15E ATWS Performance Evaluation

The information in this appendix of the reference ABWR DCD, including all subsections, tables, and figures, is incorporated by reference with the following departures.

Figure 15E-1a ATWS Mitigation Logic (ARI, FMCARD Run-In, RPT, Manual Initiation)

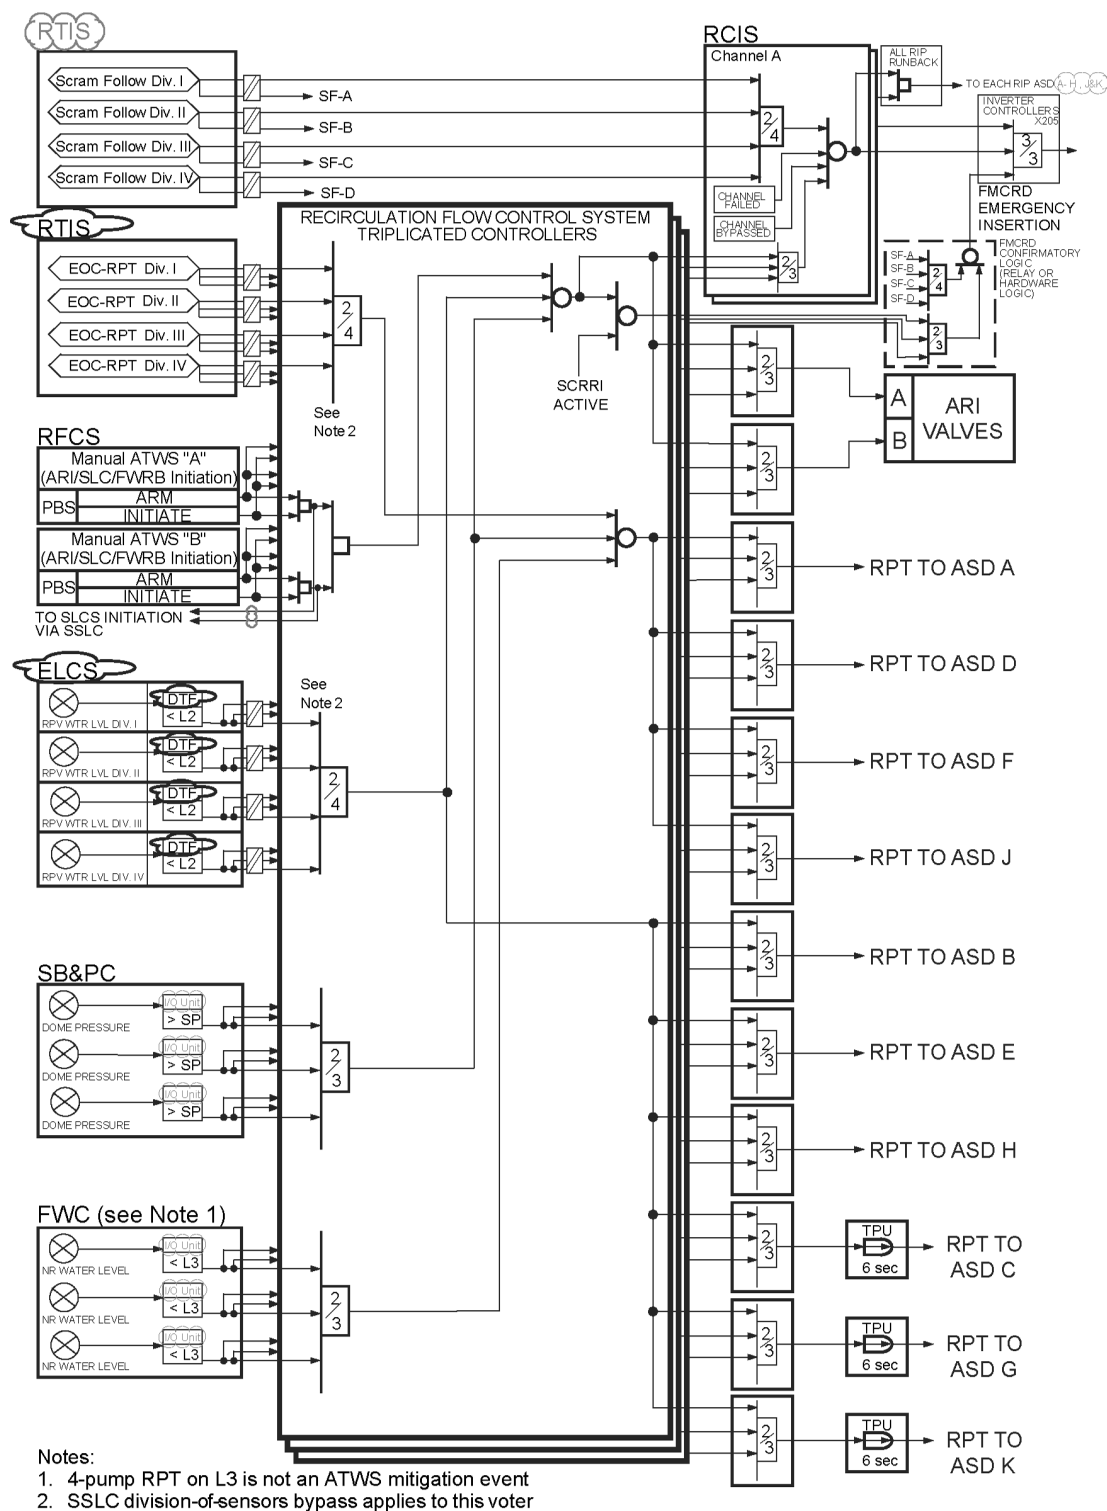
STD DEP T1 3.4-1 (Figures 15E-1a, 15E-1b, 15E-1c)

STD DEP Admin (Figure 15E-1a, Figure 15E-1b)

Figure 15E-1b ATWS Mitigation Logic (SLCS Initiation, Feedwater Runback)

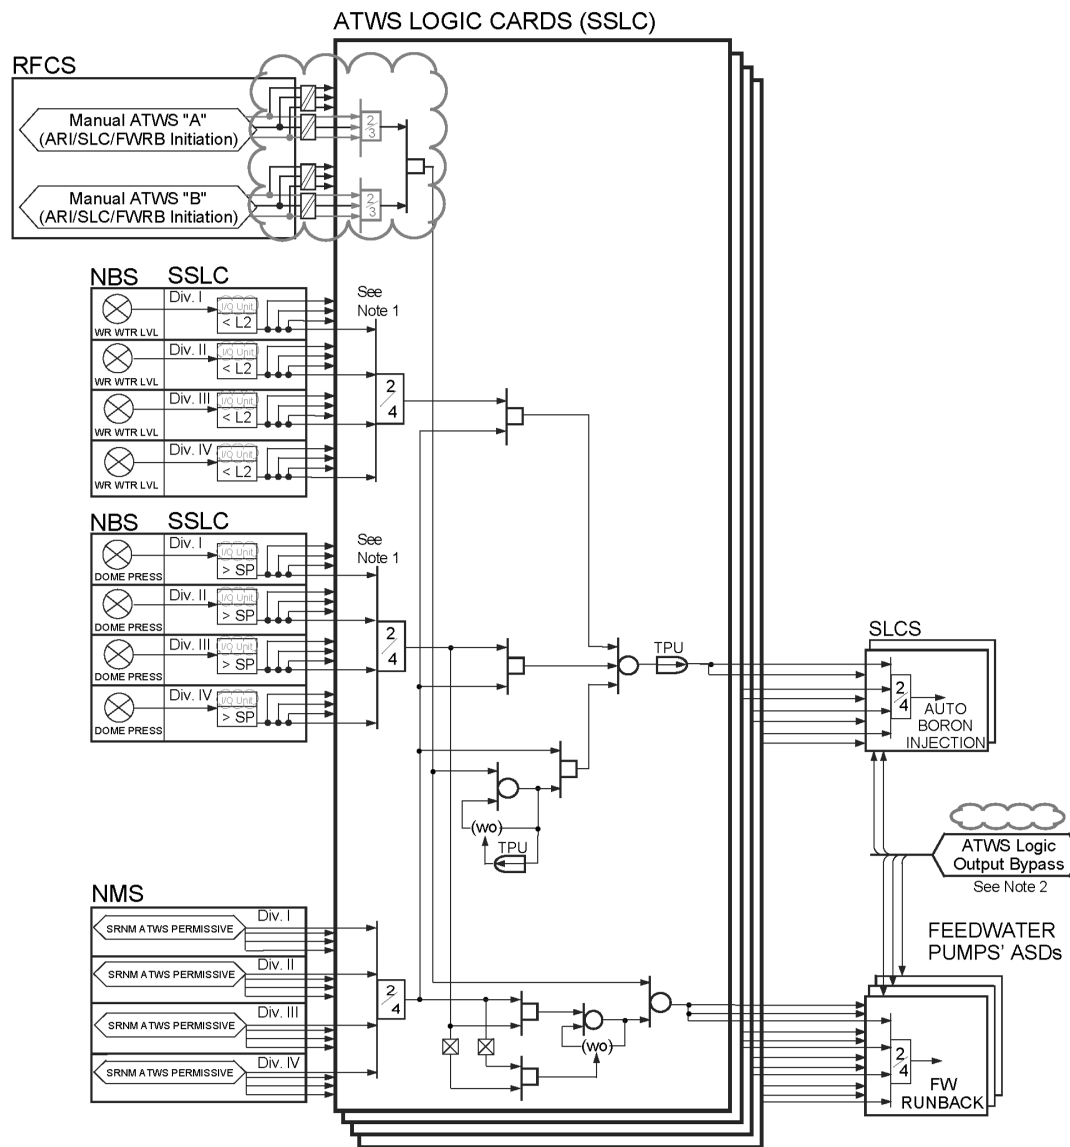
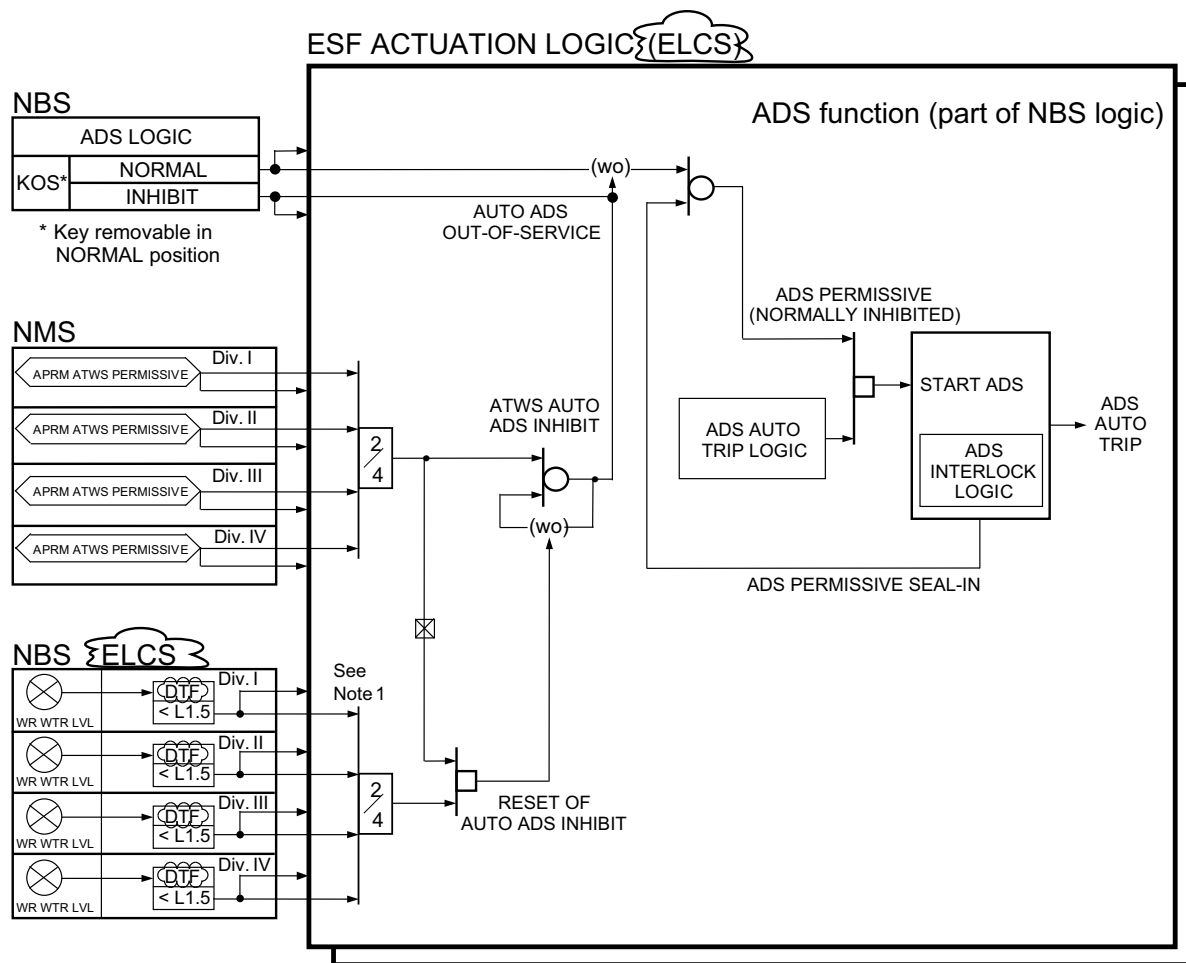
STD DEP 16.3-83 (Figure 15E-1b)
